ADDENDUM NO. 2

January 23, 2026

**MIAMI COUNTY COMMISSIONERS
HEARING ROOM RENOVATION
LPA No. 248698.00**

LIFE SAFETY PLAN

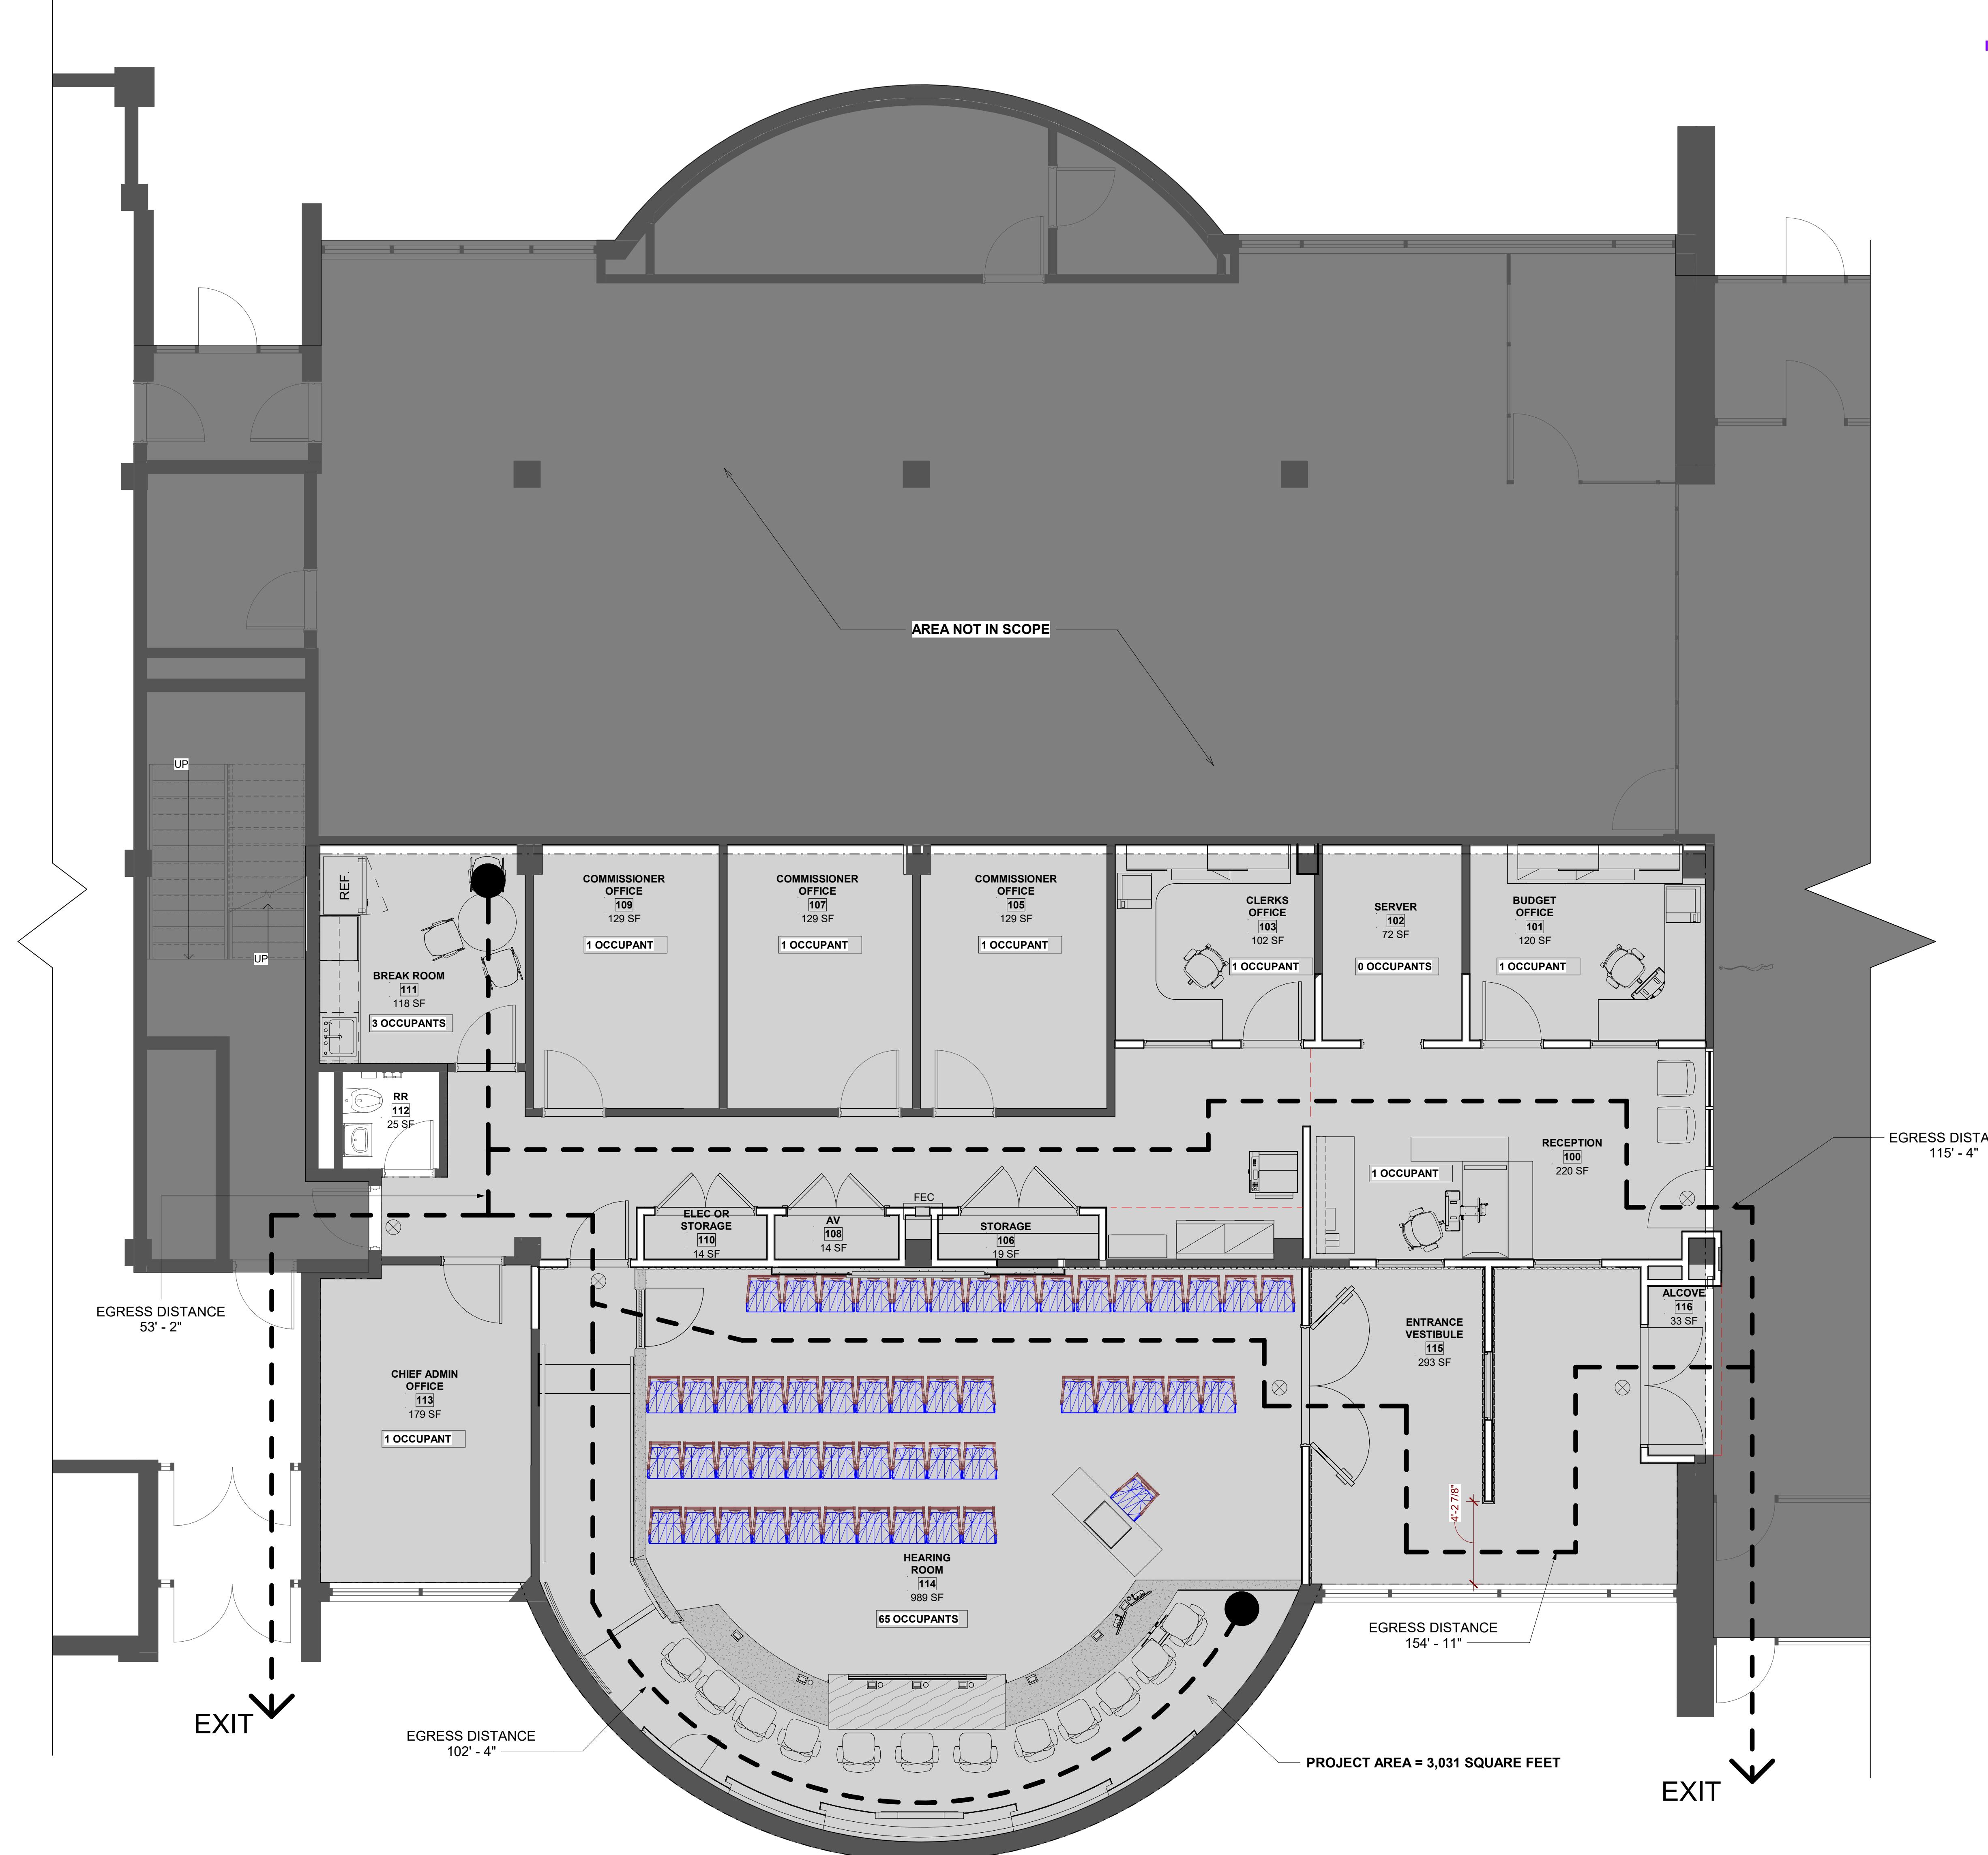
4.3 Reference: Sheet G005

A. The Life Safety Plan was moved to a new Sheet due to the changes in the code review notes on Sheet G004.

FLOOR FINISH PLAN

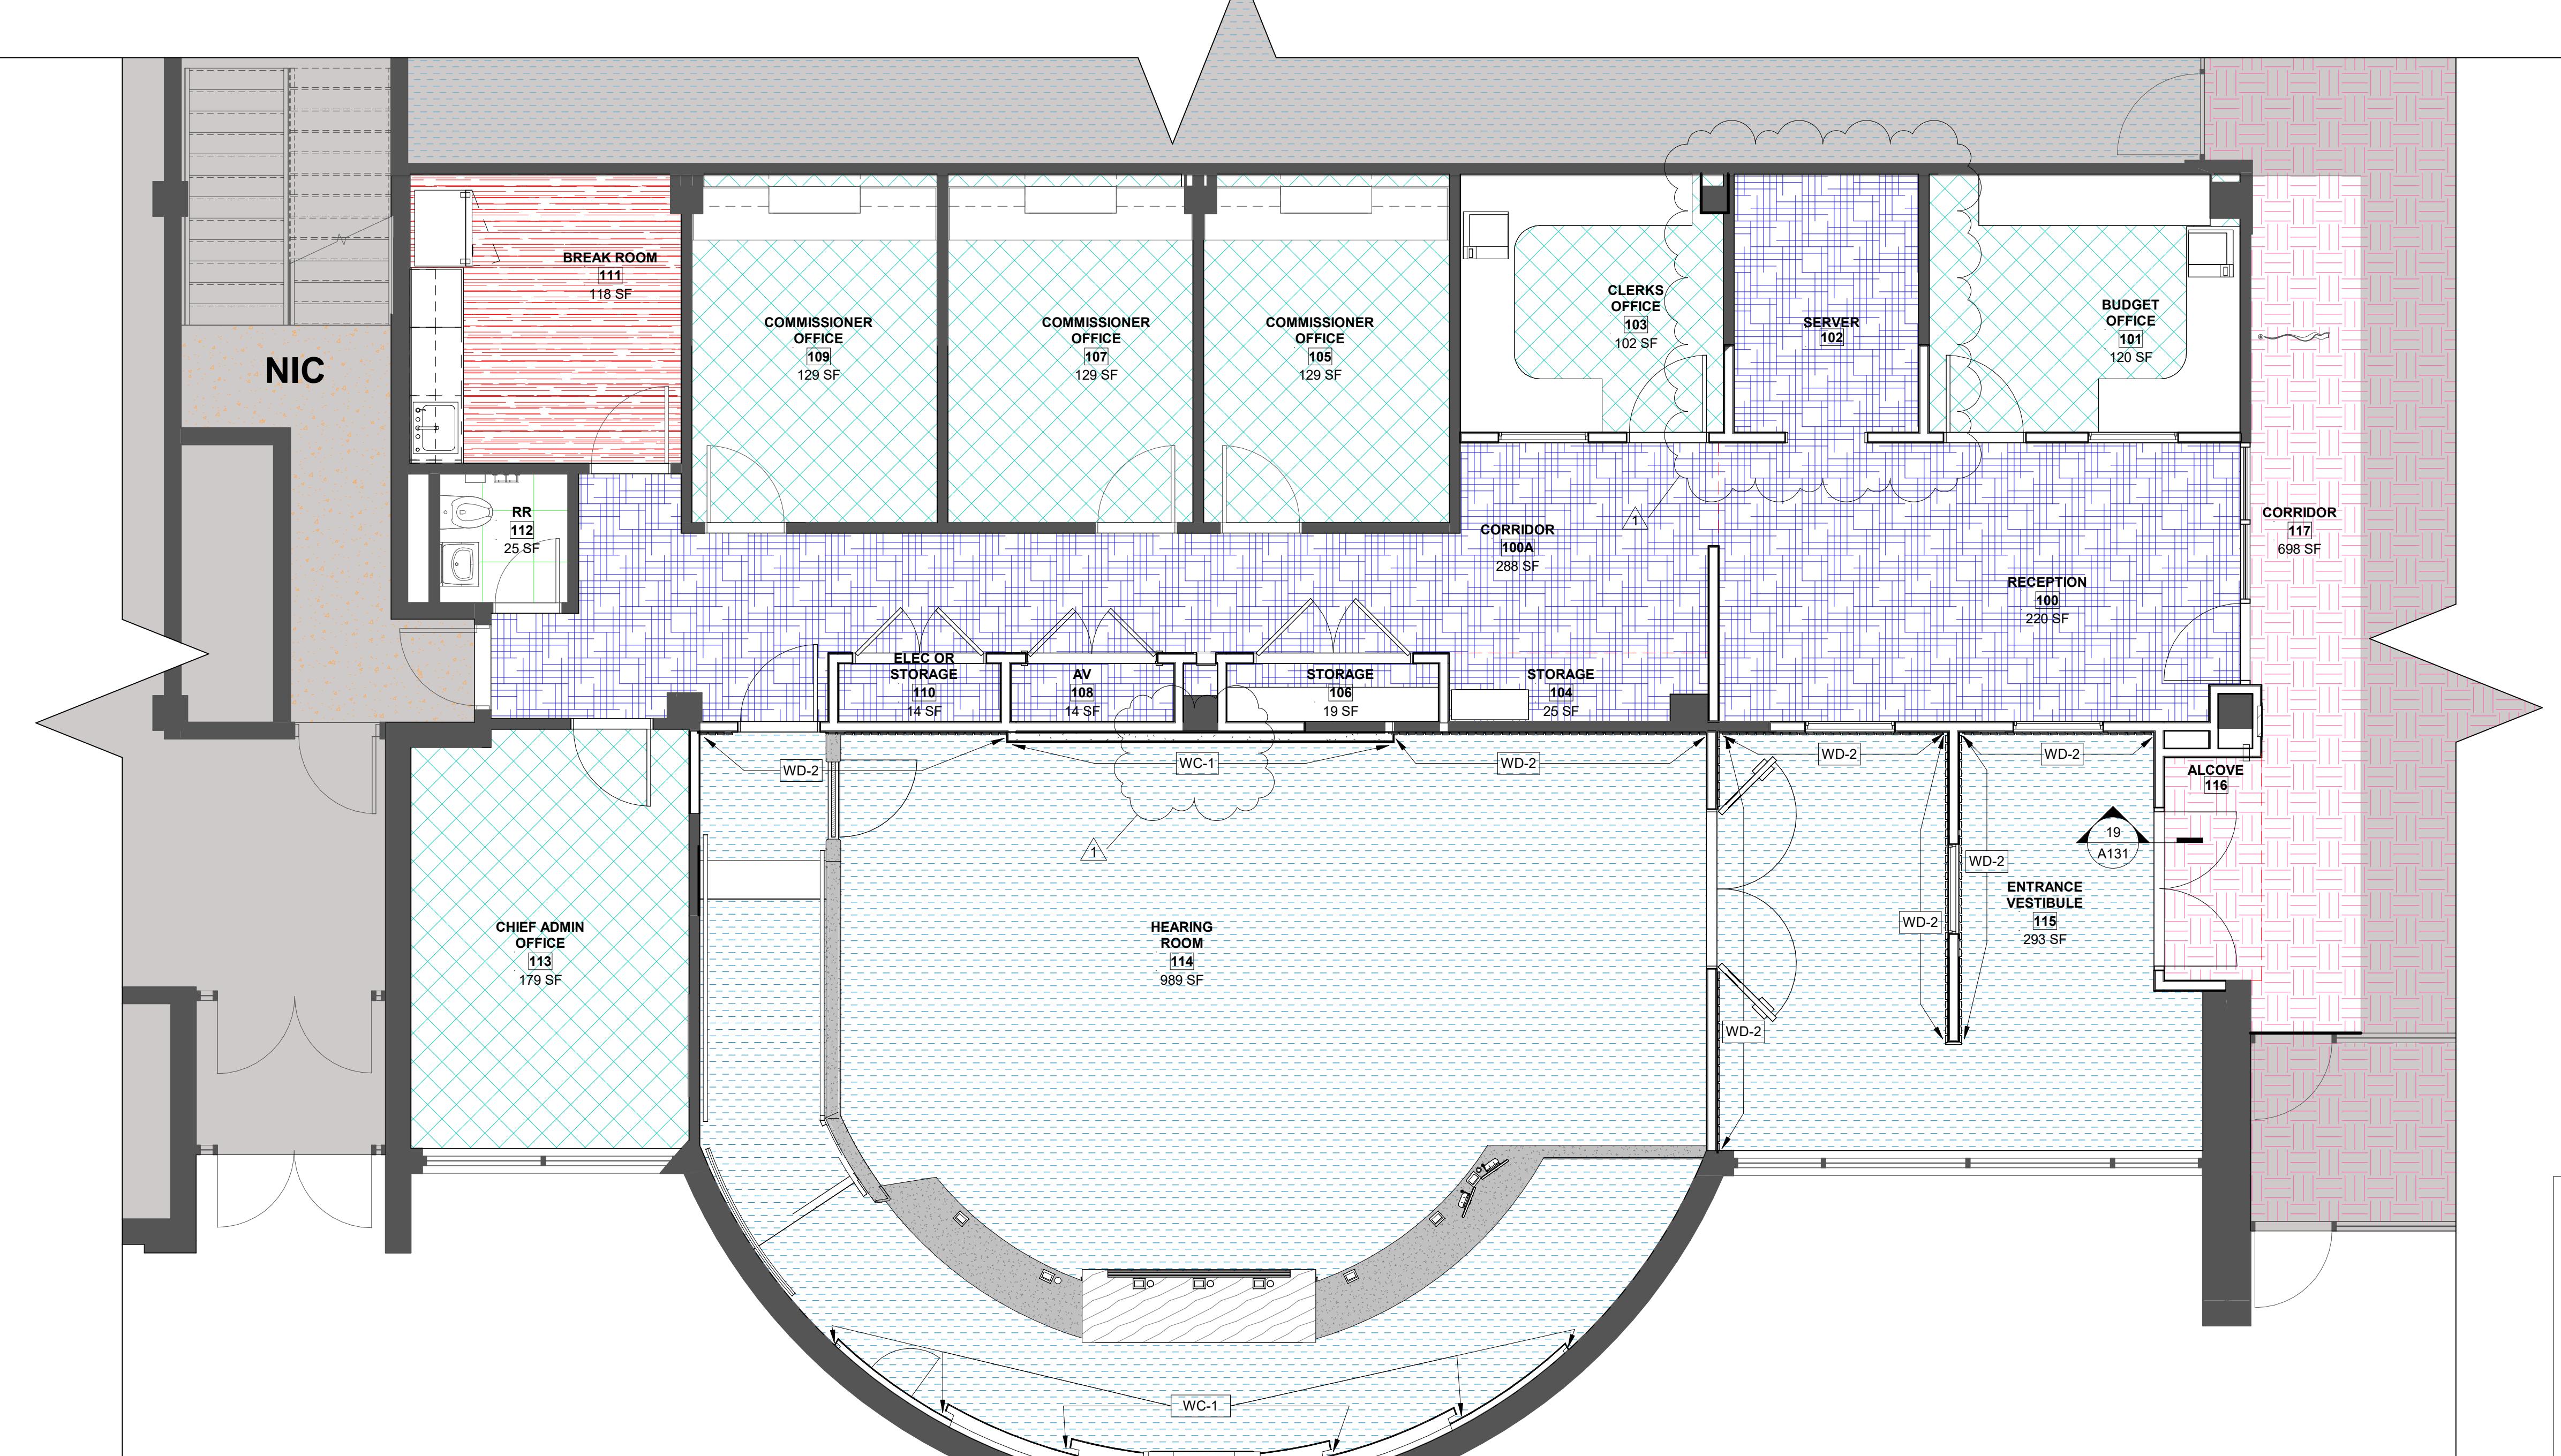
2.8 Question: Could you please have someone verify the correct flooring for Server 102 ? The Finish Schedule says CPT-2, Finish Drawing is showing CPT-3.

4.4 Reference: Sheet A131

- A. Finish Material Schedule has been updated to include PNT-5 as a finish.
- B. Revised a portion of the rear wall finish of the Hearing Room to WC-1.
- C. Updated the floor finish plan to align the floor finish of Server 102 with the Room Finish Schedule.
- D. Updated the Commissioner's Offices wall finishes to reflect a second paint color below the chair rail.
- E. A note has been added to clarify the finish intent on the wood trim elements within the Commissioner's Offices.

A. CPT-2 shall be used in Server 102.
